Access Compliance Report Public Rights-of-Way (Curb Ramps)

Intersection ID: 44610	Main Street: FIG_LN	Cross Street: PINYON_PINE_LN	Location: SE
ADA ID: C55D76DB2150	Ramp Type: Perp	Initial Pass/Fail: Pass	Overall Compliance: No Severity Score: 7.5

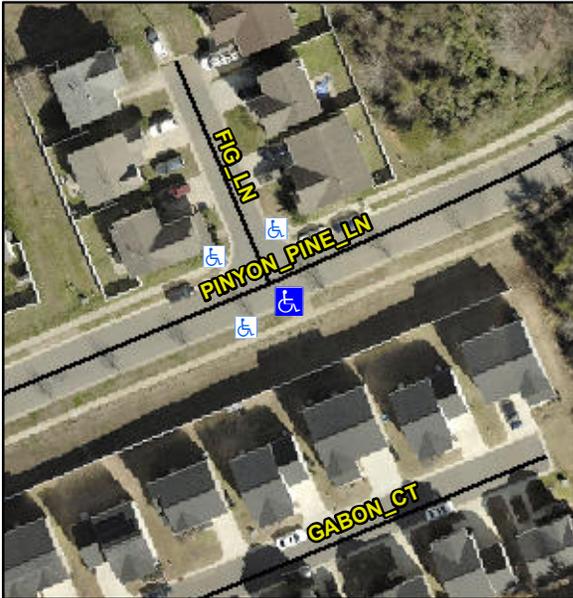
**Not Found, R304.2.1, R305.1.4,
 R305.2, R304.5.4**

Compliance	Description	Data	Compliance	Description	Data
N/A	Ramp Length (in)	84.0	Yes	Ramp Slope (%)	6.9
Yes	Ramp Width (in)	58.0	Yes	Ramp XSlope (%)	1.6
N/A	Flare Type LT	Sloped	N/A	Flare Type RT	N/A
N/A	Flare Slope LT (%)	4.6	N/A	Flare Slope RT (%)	1.2
N/A	Flare Traversable LT?	No	N/A	Flare Traversable RT?	No
No	Landing Length (in)	47.0	Yes	DWS Provided?	Yes
Yes	Landing Width (in)	58.0	Yes	DWS Contrast?	Yes
Yes	Landing Slope (%)	1.6	Yes	DWS Length (in)	25.5
Yes	Landing X Slope (%)	0.6	No	DWS Full Width?	No
N/A	Landing Curb? (Y/N)	No	No	DWS Offset (in)	2.5
N/A	Shared Landing?	Yes			
Yes	Gutter Ponding?	No	No	Gutter Slope (%)	5.1
Yes	Gutter Lip Ht (in)	0.0	Yes	Gutter X Slope (%)	1.9
N/A	Painted X Walk1?	No	N/A	Painted X Walk2?	N/A
	X Walk 1 Direction	To N		X Walk 2 Direction	N/A
N/A	X Walk 1 Width (in)	N/A	N/A	X Walk 2 Width (in)	N/A
	X Walk 1 Slope (%)	2.0		X Walk 2 Slope (%)	N/A
	X Walk 1 X Slope (%)	1.4		X Walk 2 X Slope (%)	N/A

Possible Solutions:
**Remove & Replace Entire Ramp.
 Remove & Replace Gutter.**
